PLANNING BOARD

i. Major Site Plan and Traffic Movement Permit; 385 Congress Street; Portland Music Holdings, LLC, Applicant. The Planning Board will hold a hybrid workshop to consider a major site plan and traffic movement permit application to facilitate the development of a 65,340 square foot entertainment venue with capacity for up to 3,310 patrons, which would also include food and beverage services, administrative offices, and indoor and outdoor lounge area, and back-of-house operations areas. The subject property is located downtown, and is within the B-3 Downtown Business zone. A project and plan summary are available for viewing on the city's CSS Portal (<https://css.portlandmaine.gov/>) by referencing Plan Number PL-003179-2024.

To: Chair Brandon Mazer & Members of the Planning Board
From: Taylor Colbeth
Date: March 21, 2025
Re: 385 Congress Street – Live Nation Music Venue
Project ID: PL-003197-2024
CBL: 027 D003
Meeting Date: March 25, 2025

1937-105 LS.dwg TAB LANDSCAPE PLAN

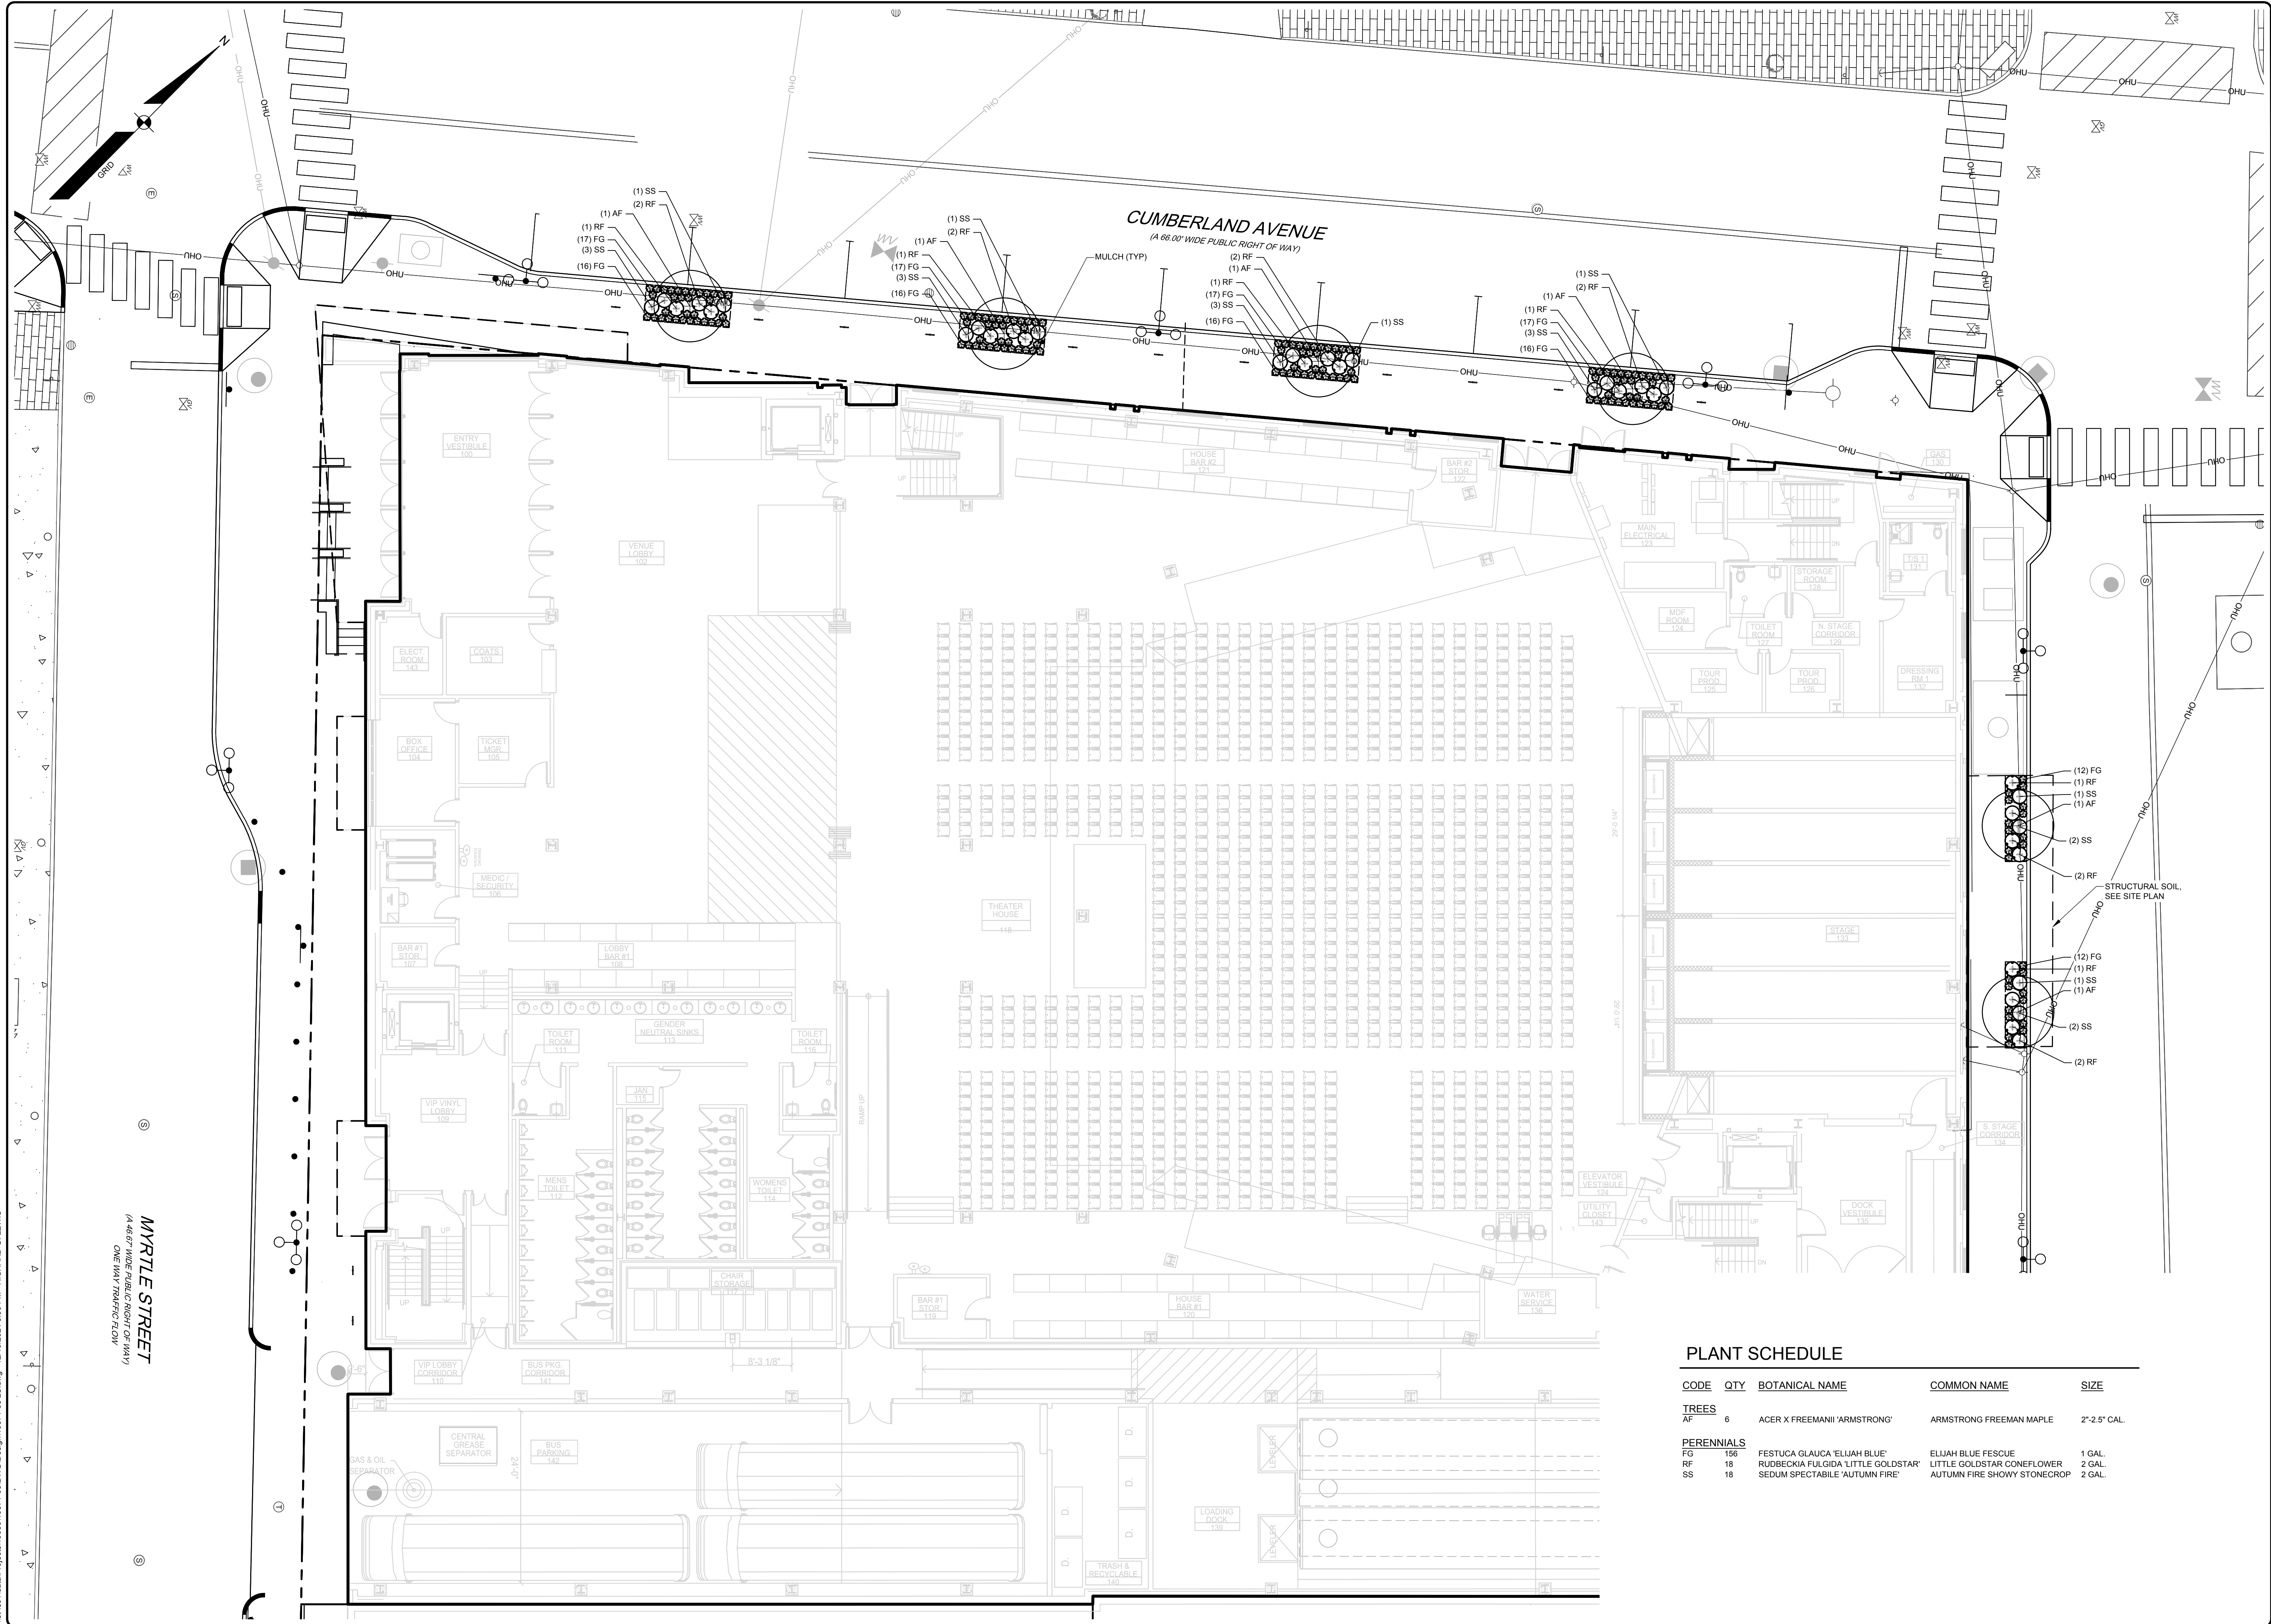
The applicant has provided a landscape plan that proposes four street trees along Cumberland Ave and two along Pearl Street, for a total of six street trees. Per Standard 13.6.2.B.5, one street tree is required for every 25-35 feet of street frontage. The proposed development has frontage along Myrtle Street, Cumberland Avenue, and Pearl Street and is required to provide 4, 7, and 5 trees, respectively, for a total of 16 street trees.

- The applicant shall review Standard 13.6.2.B.5 and update site plan accordingly. If the applicant is unable to provide additional street trees along the building's frontage, the applicant will be required to contribute to the City's tree fund, per Technical Manual Section 4.1.3.
- The applicant is also encouraged to work with City staff to identify other areas within the neighborhood where street trees could be planted.
